37/03-05X 7221 Cedar Ave
Takomá Park Historic District

MEMORANDUM

SUBJECT: Historic Area Work Permit #381671—Rear Addition and alterations

HISTORIC PRESERVATION COMMISSION STAFF REPORT

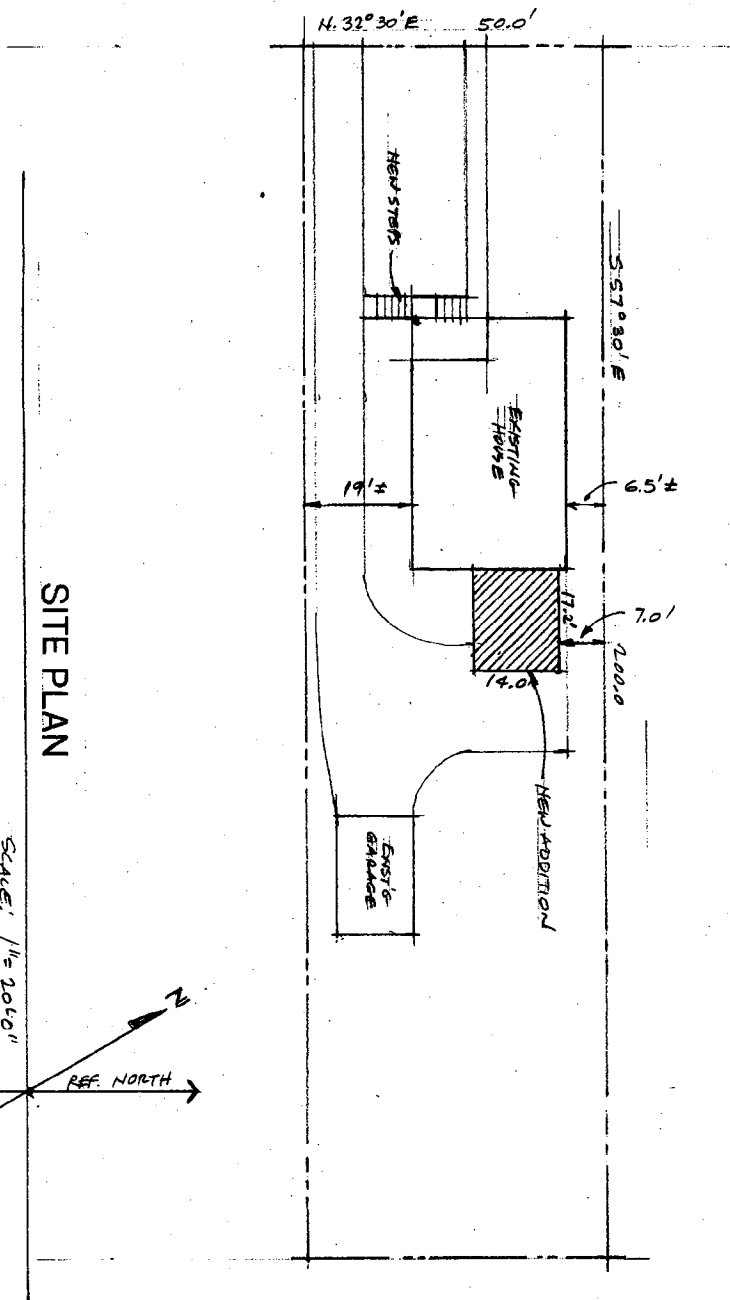
true board & batten ?/

Pref. Wood clapboard

3rd level floor plan

Copper panel?

MDO? No way

2/2 windows

on rear to be reused?

original
siding restored?
